Intel[®] Celeron[®] Processor Specification Update

Release Date: October 2001

Order Number: 243748-038

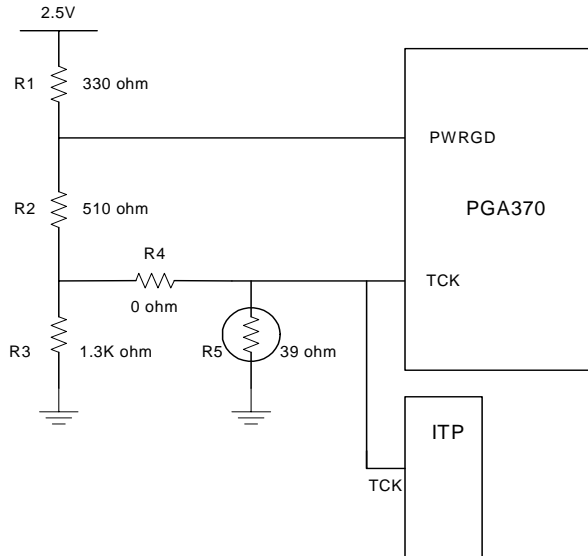
Implication: This issue can lead to intermittent system power-on boot failures. The occurrence and repeatability of failures is system dependent, however all systems and processors are susceptible to failure. In addition, the processor may fail to stop execution during the event of a valid THERMTRIP# assertion resulting in the potential for permanent processor damage.

Workaround: To prevent the risk of power-on boot failures or catastrophic thermal failures, a platform workaround is required. The system must provide a rising edge on the TCK signal during the power-on sequence that meets all of the following requirements:

- Rising edge occurs after Vcc_core is valid and stable
- Rising edge occurs before or at the de-assertion of RESET#
- Rising edge occurs after all Vref input signals are at valid voltage levels
- TCK input meets the Vih min and max spec as mentioned in EMTS

Specific workaround implementations may be platform specific. The following examples have been tested as acceptable workaround implementations.

Please note, the example workaround circuits attached require circuit modification for ITP tools to function correctly. These modifications must remove the workaround circuitry from the platform and may cause systems to fail to boot. Review the accompanying notes with each workaround for ITP modification details. If the system fails to boot when using ITP, issuing the ITP 'Reset Target' command on failing systems will reset the system and provide a sufficient rising edge on the TCK pin to ensure proper system boot.
